Technical Memorandum — TM003
Vanderbilt Corridor and One Vanderbilt
CEQR Number 14DCP188M
May 15, 2015

B. DESCRIPTION OF CITY COUNCIL MODIFICATIONS

Figure 1 shows a comparison of the ground-floor plan under the City Council Modifications and the CPC Modified Actions.

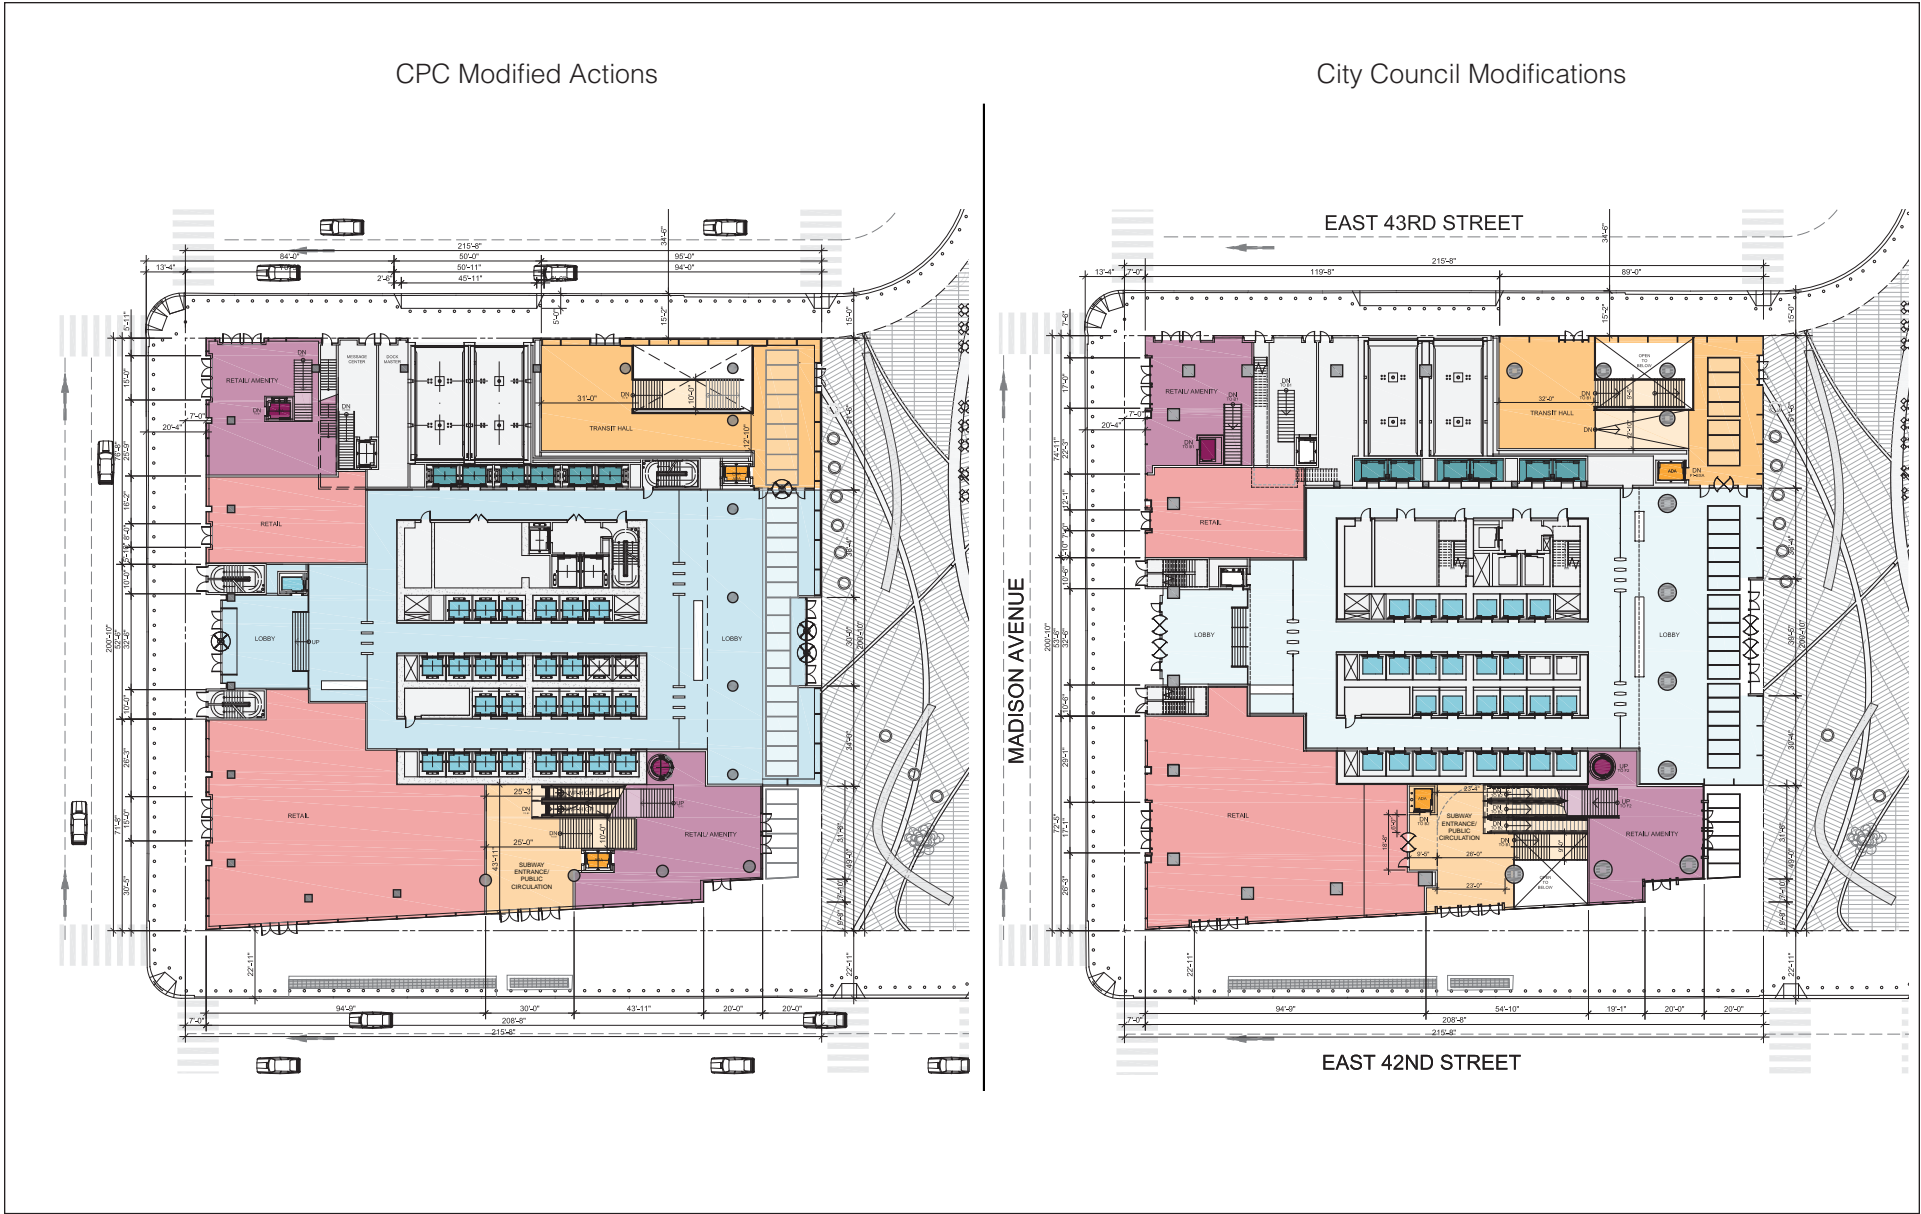
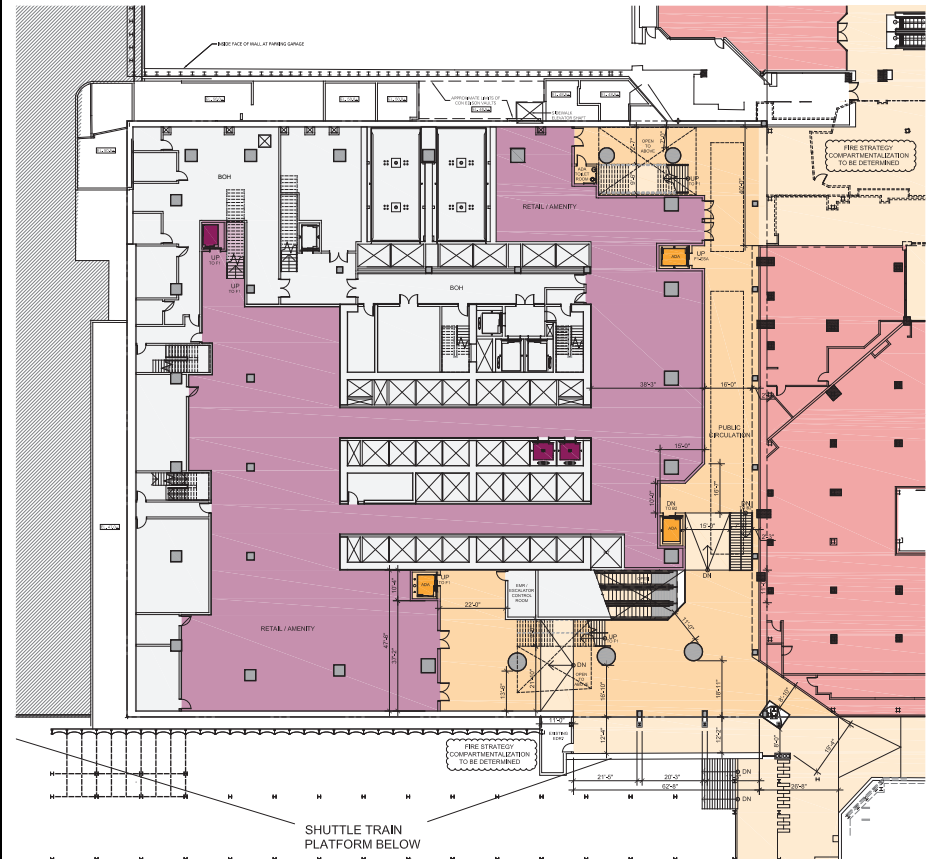
EAST 42ND STREET TRANSIT ENTRANCE (GROUND FLOOR)

- The street frontage of the new transit entrance on East 42nd Street would be enlarged by 24 feet to increase the entrance's visibility and presence.
- The interior of the new transit entrance would be increased by 30 percent, creating a more generous public entrance.
- A two-story open volume from the ground floor to the B1 level would be created to bring daylight to the below-grade circulation corridors.

Figure 2 shows a comparison of the B1 level under the City Council Modifications and the CPC Modified Actions.

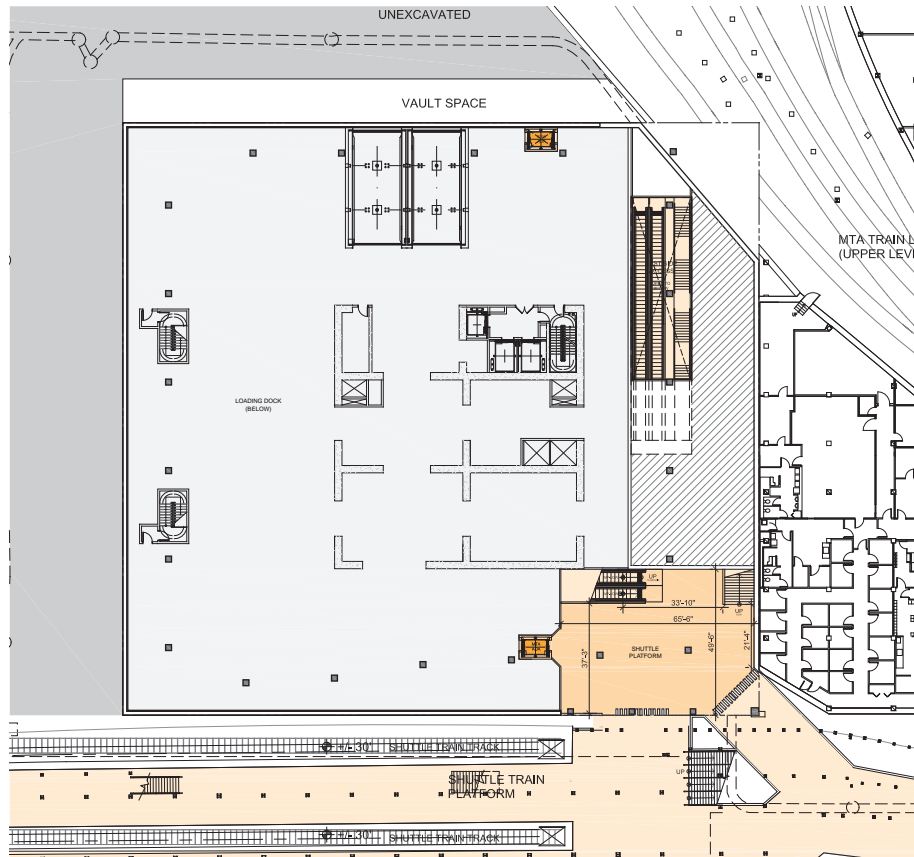
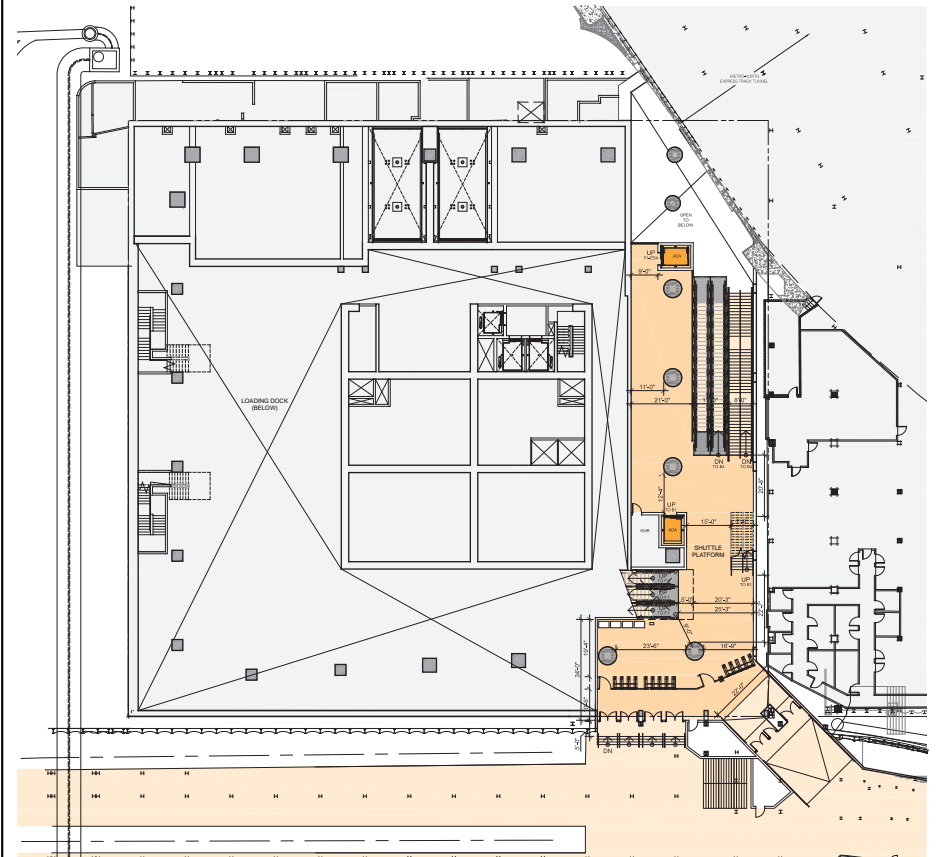
GRAND CENTRAL CONCOURSE LEVEL (B1)

- The new two-story open volume created in the East 42nd Street transit entrance would bring daylight to the B1 level, improving the commuter experience.
- A stairway to the B2 level adjacent to the east wall of the building would be moved slightly north but located in the same public circulation passageway as the stairway in the CPC Modified Actions.
- A public bathroom would be provided in the transit hall.

Figure 3 shows a comparison of the B2 level under the City Council Modifications and the CPC Modified Actions.

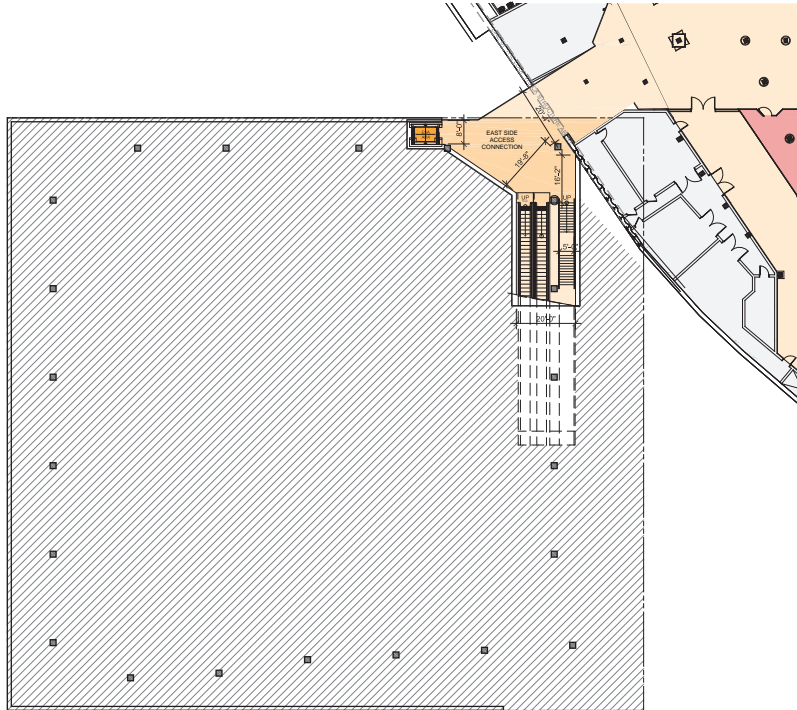
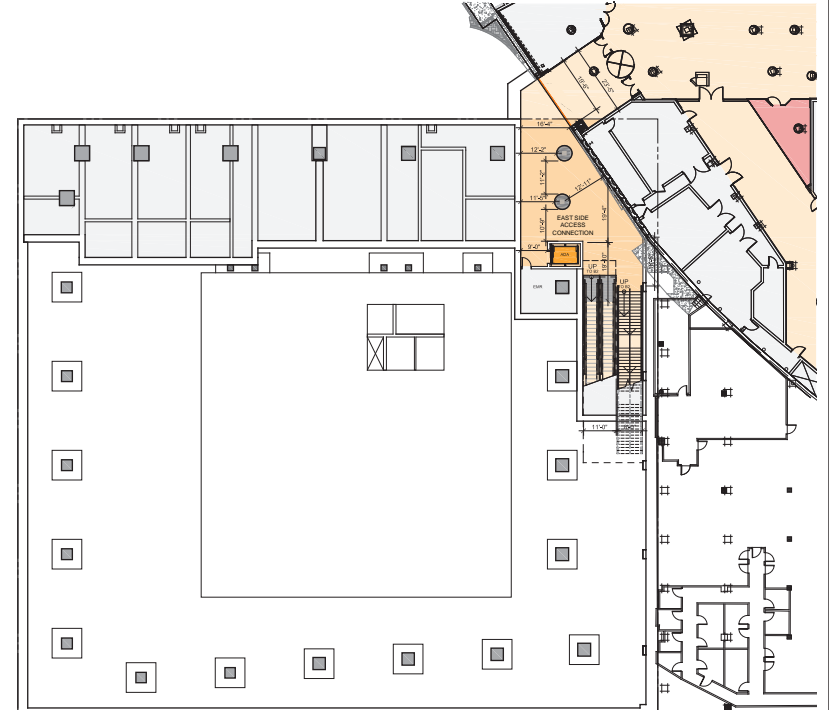
- A new direct access corridor would be created to connect East Side Access with the No. 4, 5, 6, 7 and shuttle subway lines, resulting in a 75 percent increase in on-site public space at the subway platform level as compared to the CPC Modified Actions.

- Elevators would be relocated to provide for better visibility and accessibility. The north elevator, which previously did not open on this level, would be repositioned to open next to the East Side Access escalators, while the south elevator would be repositioned between the East Side Access escalators and the escalators to street level.
- A third escalator would be provided from the B2 level directly to street level, increasing pedestrian flow capacity.
